# 9.0 RESPONSES TO COUNCIL FEEDBACK

# SUMMARY

## DRAWING SET 45 McLAREN STREET, NORTH SYDNEY

# ARCHITECTURAL SET AMENDED PP

# RESPONSES TO COUNCIL FEEDBACK

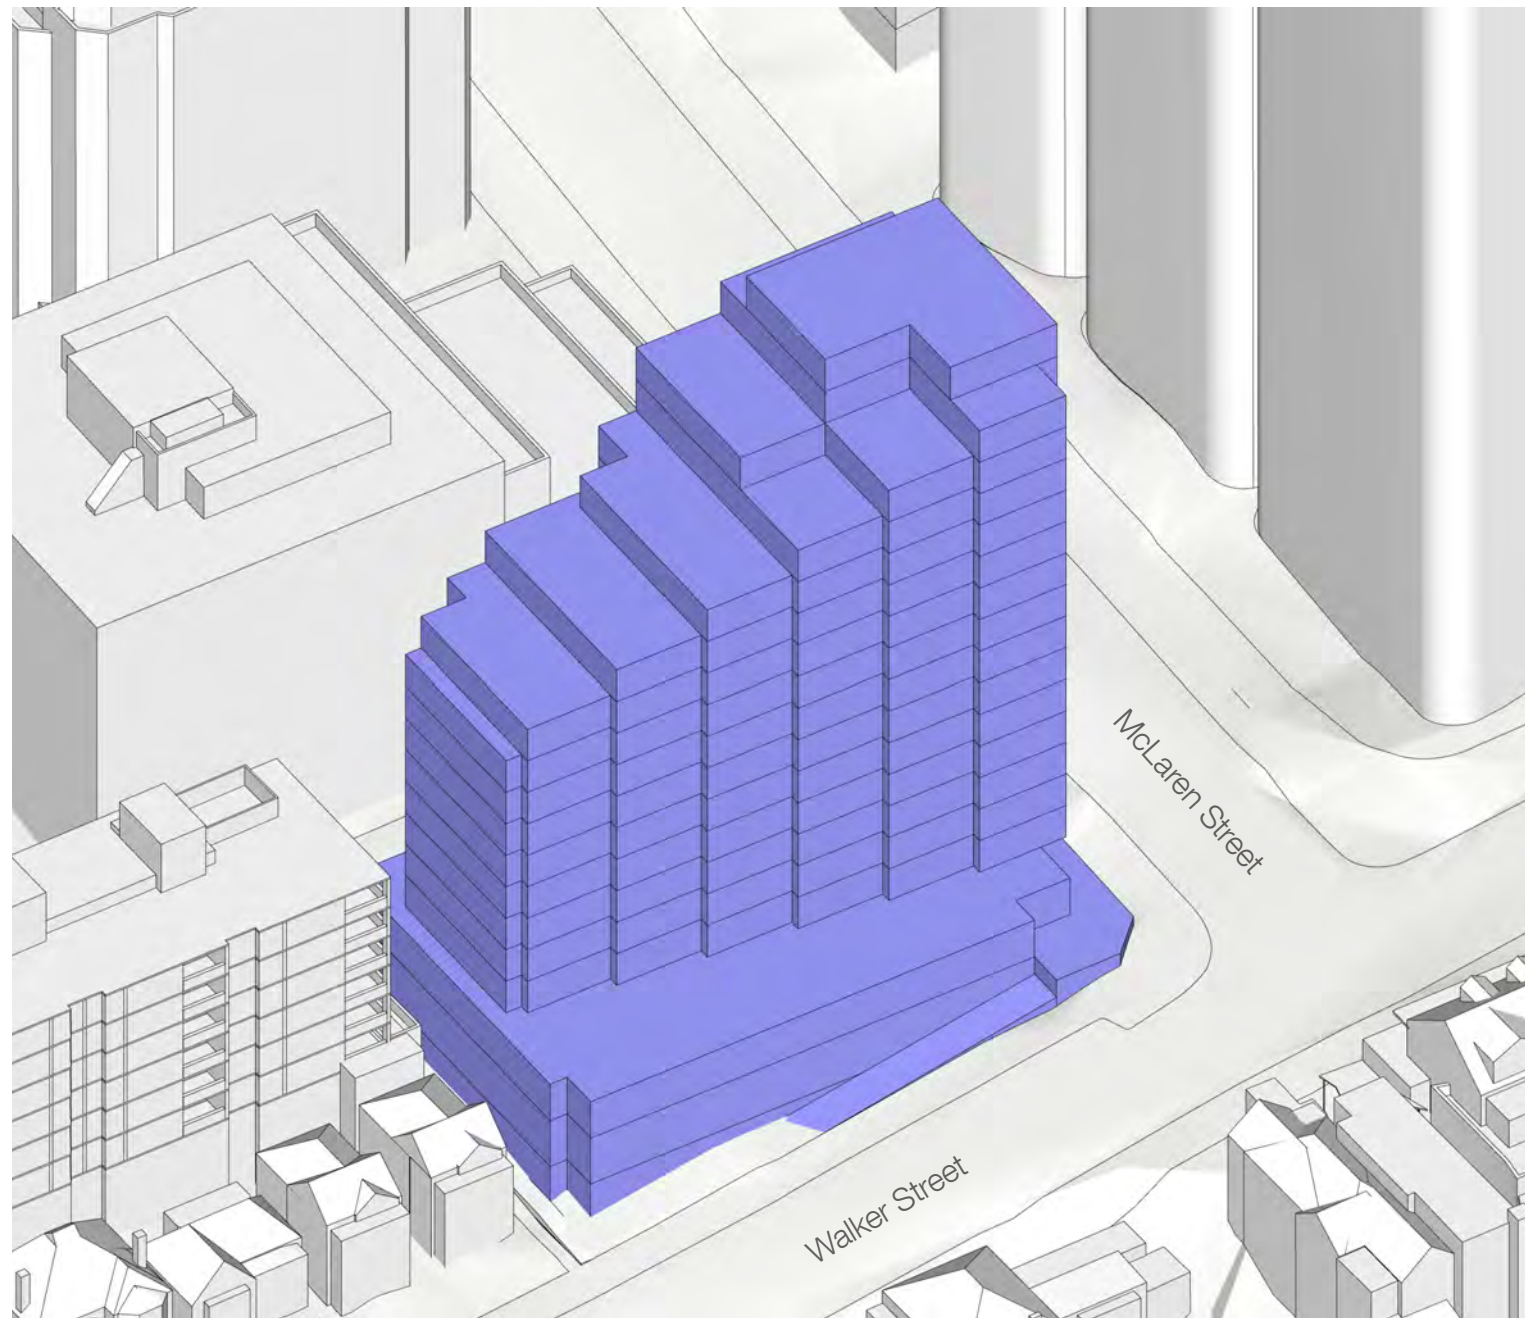
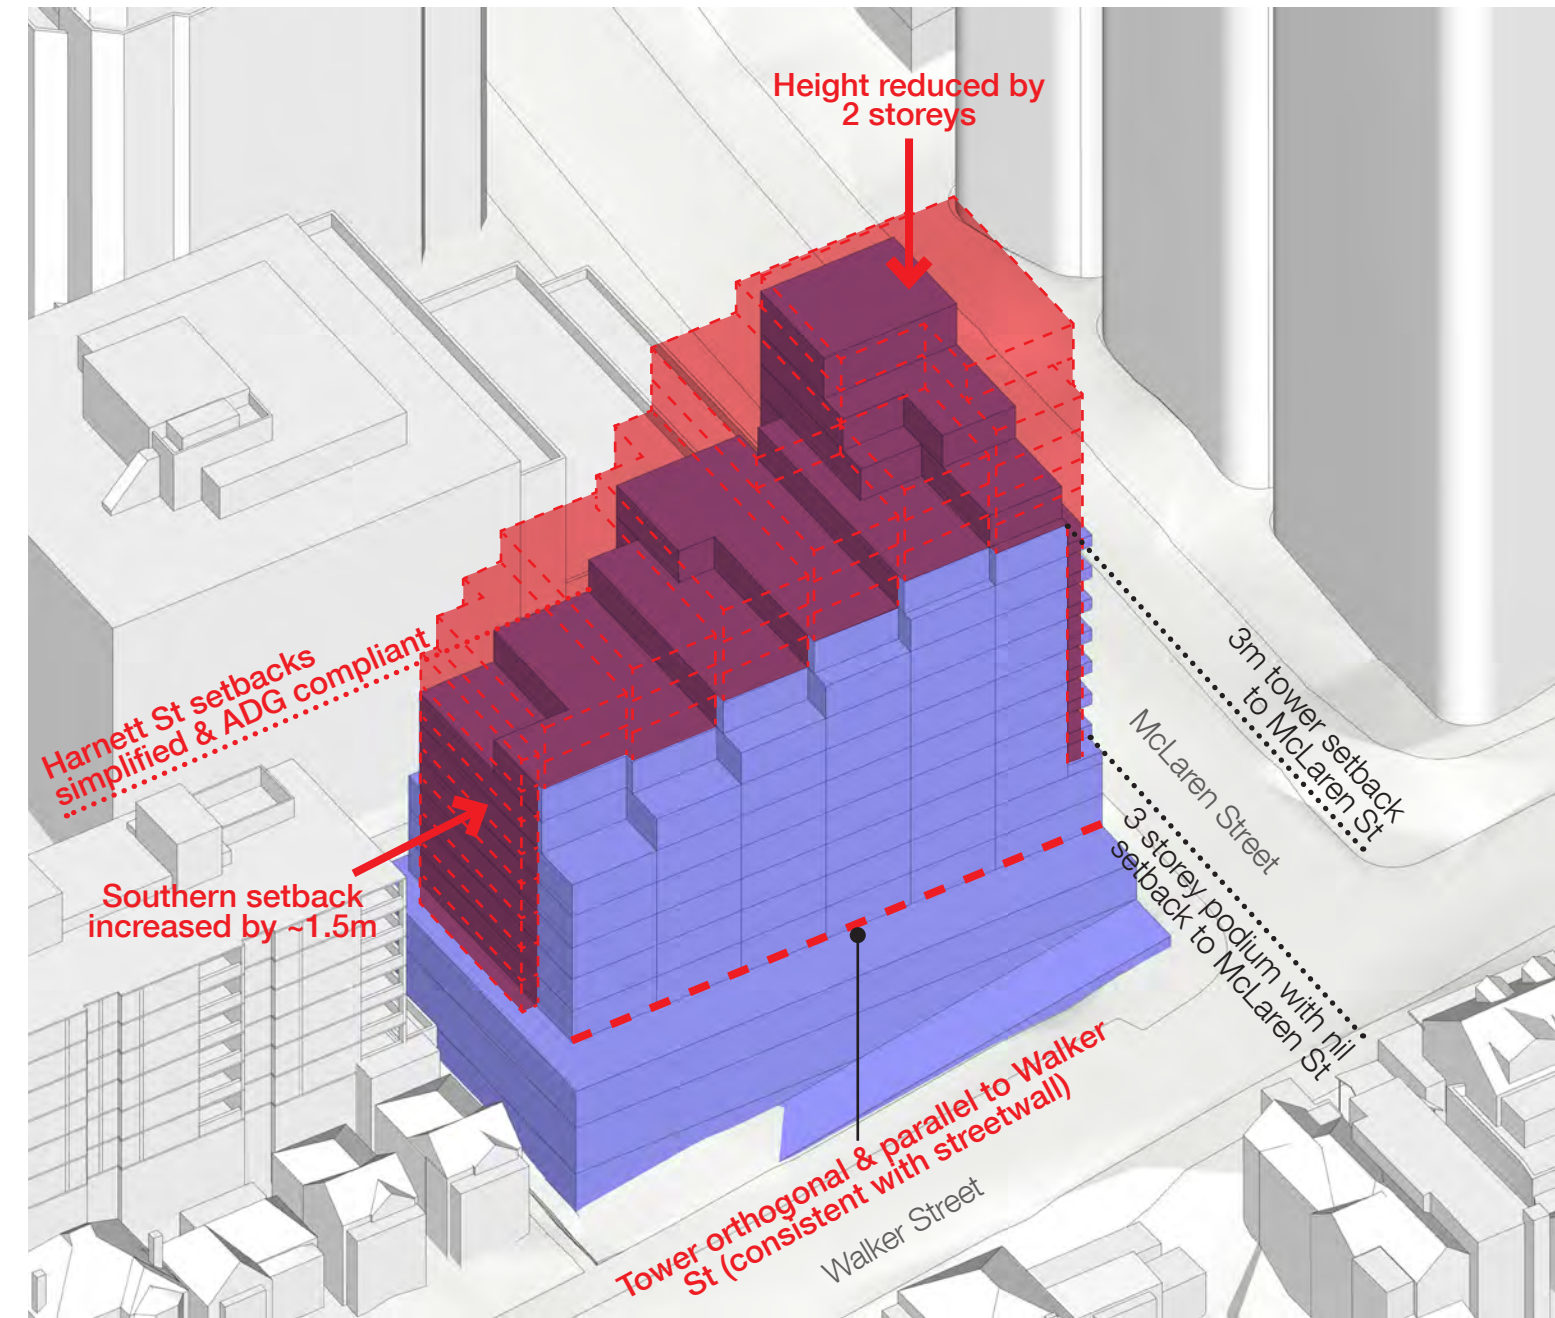
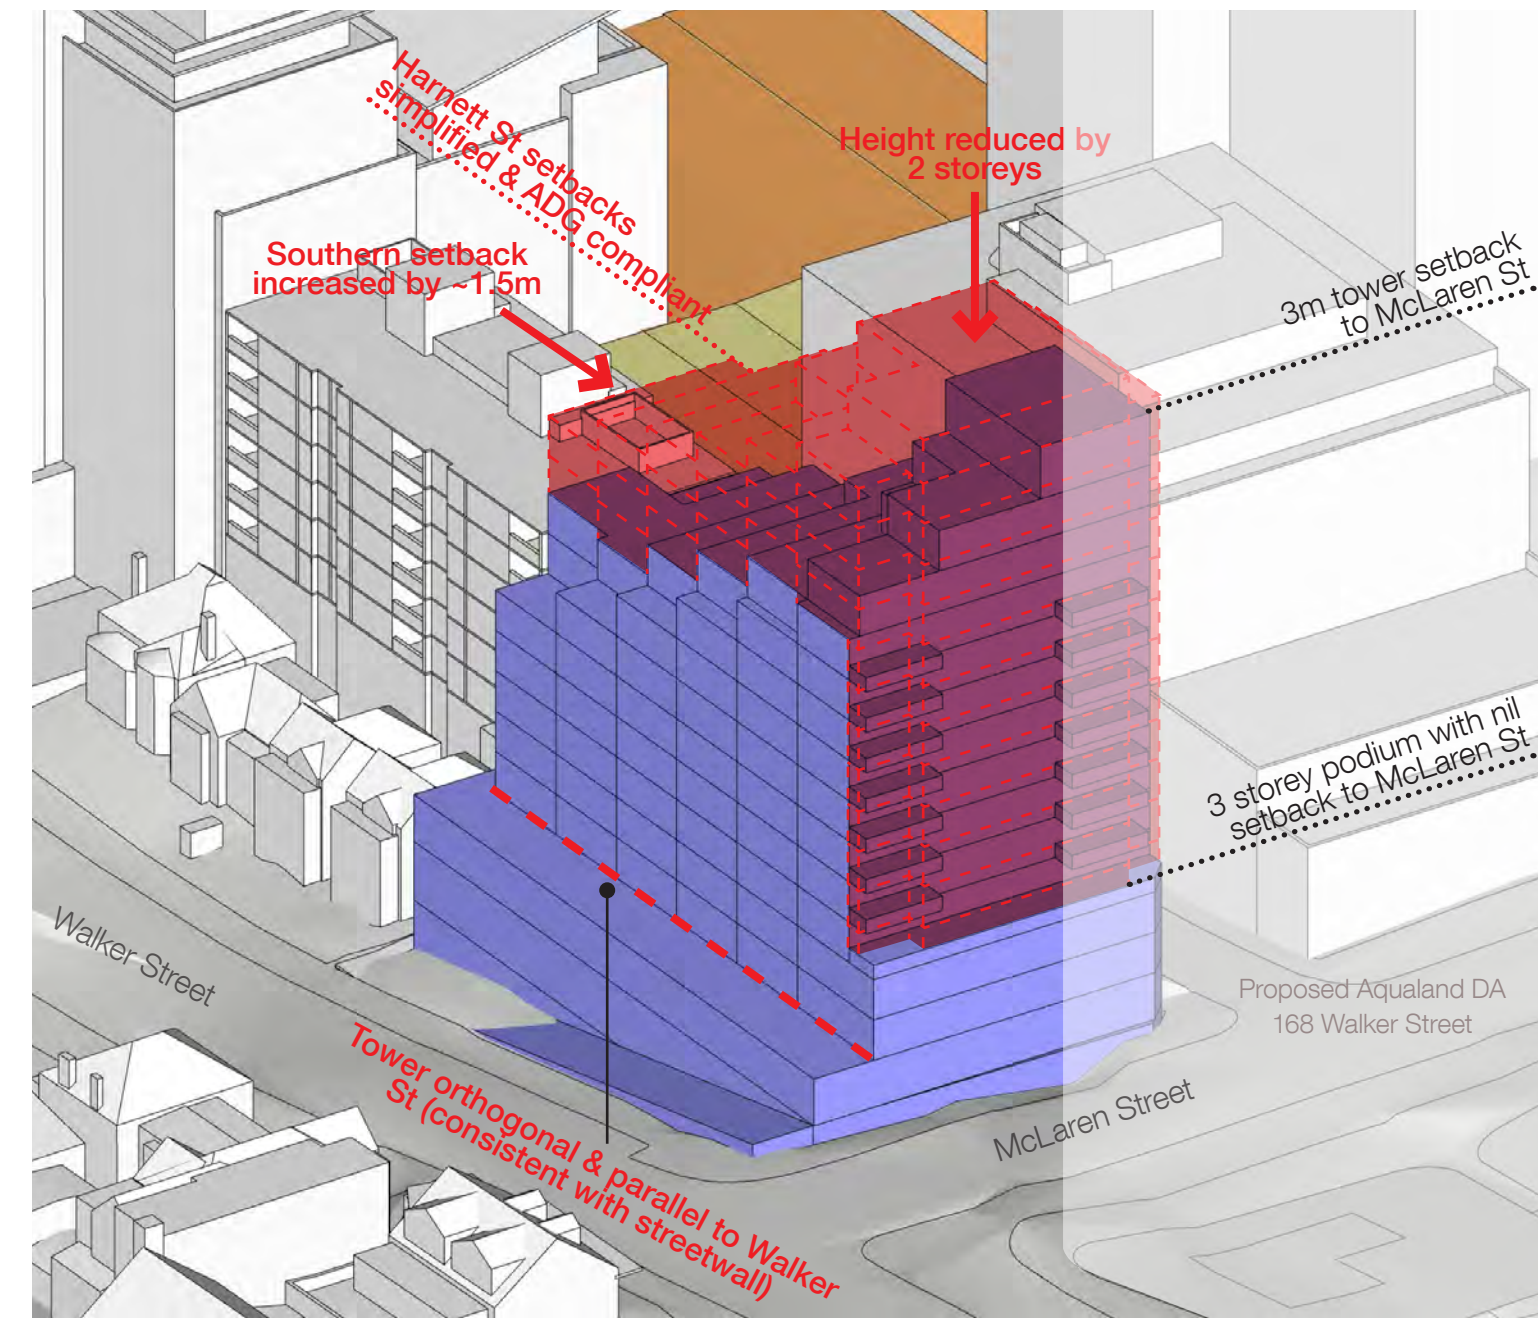
<p><b>Council's Requested Amendments:</b></p> <p>Height Reduction - "to avoid overshadowing to the main plaza"</p>	<p><b>Council's Requested Amendments:</b></p> <p>North Setback - Introduce a 3-storey podium with nil setback and 3m tower setback to McLaren Street</p>	<p><b>Council's Requested Amendments:</b></p> <p>Walker Street Alignment - "parallel to the alignment of Walker Street"</p>	<p><b>Council's Requested Amendments:</b></p> <p>Harnett Street Setback - "address ADG separation requirements"</p>	<p><b>Council's Requested Amendments:</b></p> <p>South Setback - "address ADG separation requirements"</p>
<p><b>Amended Planning Proposal Response:</b></p> <ul style="list-style-type: none"> <li>- Height reduced by 2 storeys</li> <li>- Stepped form to allow retention of solar access to the Ward Street Plaza's Central Square from 9am at any time of the year</li> </ul>	<p><b>Amended Planning Proposal Response:</b></p> <ul style="list-style-type: none"> <li>- Massing revised to introduce a 3-storey podium with nil setback and 3m tower setback to McLaren Street</li> </ul>	<p><b>Amended Planning Proposal Response:</b></p> <ul style="list-style-type: none"> <li>- Tower massing revised to create orthogonal street wall parallel to Walker Street</li> <li>- Upper levels setback to maintain solar access to residential apartments at 150 Walker Street</li> </ul>	<p><b>Amended Planning Proposal Response:</b></p> <ul style="list-style-type: none"> <li>- Tower massing revised to simplify building setbacks along southern portion of Harnett Street facade. Including;</li> <li>- 6m setback from Harnett Street centreline up to Upper Ground Level</li> <li>- 7.5m setback from Harnett Street centreline from Level 01-03</li> <li>- 9m setback from Harnett Street centreline from Level 04-09</li> </ul>	<p><b>Amended Planning Proposal Response:</b></p> <ul style="list-style-type: none"> <li>- Tower setback increased to ~4.5m from southern boundary</li> </ul>

- reduction in overall maximum building height from RL118.7 to RL113.8
- the stepped form of 12-16 storeys (stepping south to north) adjusted to 10-14 storeys - reduction of 2 storeys
- reduction in FSR from 7.5:1 to 6.25:1
- increased building separation to the south boundary and Harnett Street
- simplified building form to provide orthogonal frontage to Walker Street, consistent with the prevailing streetwall
- introduction of a 3-storey podium with nil setback and 3m tower setback to McLaren Street in accordance with council feedback and the DCP provisions

# SOLAR ACCESS DESIGN EVOLUTION

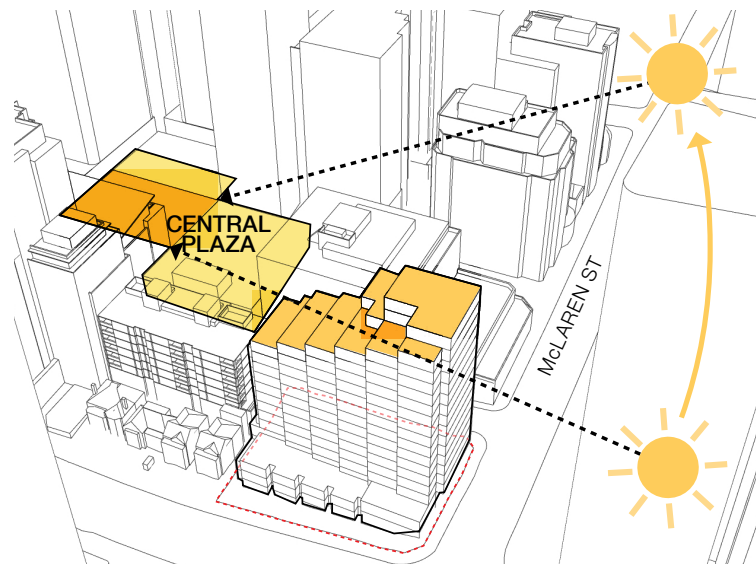
Post-lodgement advice from Council (24 Nov 2020, 12 Jan 2021) noted that there should be "no additional overshadowing of the future public squares at ANY time of the day year round."

Subsequent feedback (5th March 2021) noted "the concept proposal must be revised to ensure that any increase in additional overshadowing of to the northern square is minimised to the greatest extent possible."

Final feedback from council on the amended planning proposal submitted in June 2021 stated that solar access to the Central Square of the future Ward Street Plaza should be maintained from 9am at any time of the year.

Stepped tower to allow sun to Civic Square.

## COUNCIL'S REQUESTED AMENDMENTS

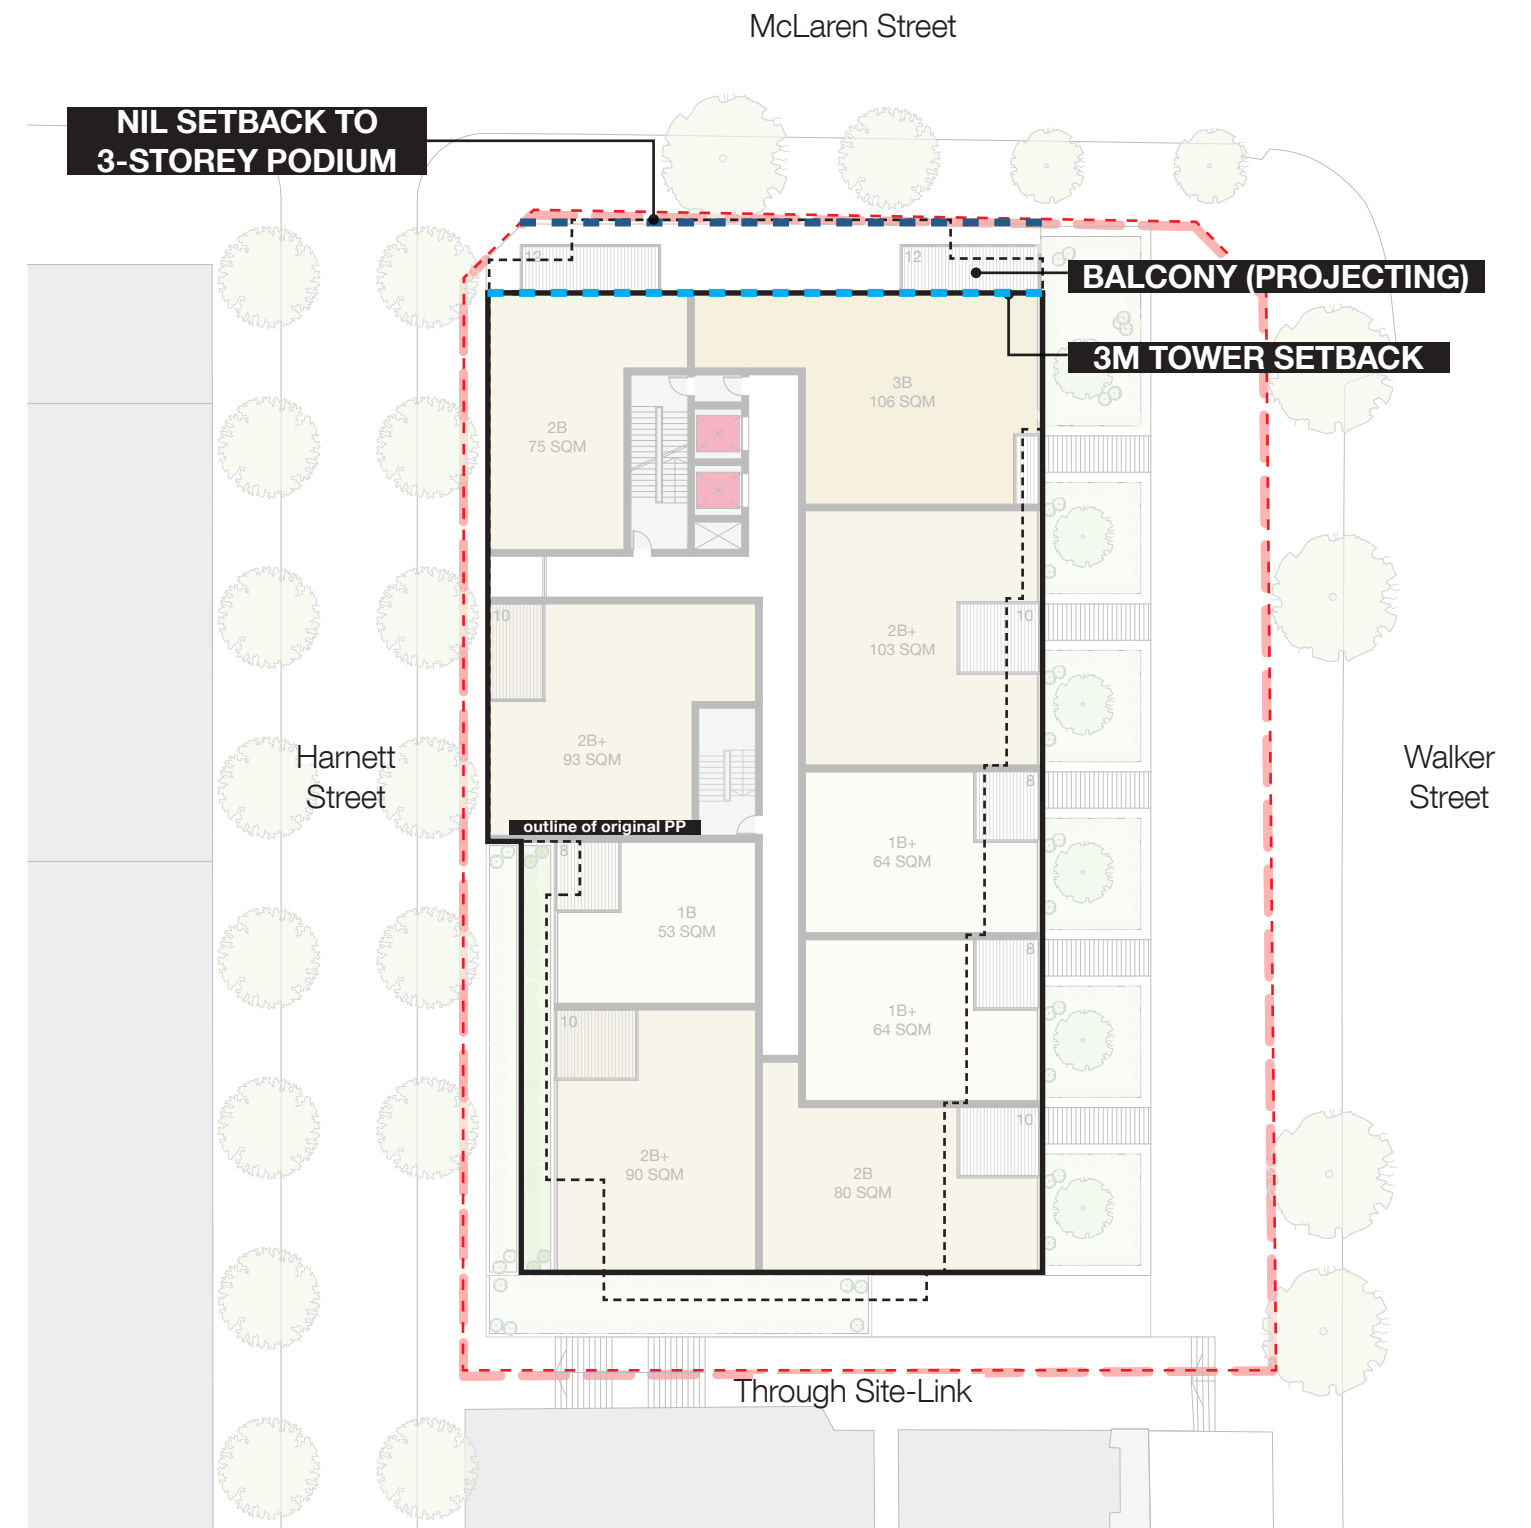
**North Setback - introduce a 3-storey podium with nil setback and 3m tower setback to McLaren Street in accordance with the DCP provisions**

Massing revised to introduce a 3-storey podium with nil setback and 3m tower setback to McLaren Street in accordance with council feedback and the DCP provisions. Balconies project beyond this 3m setback.
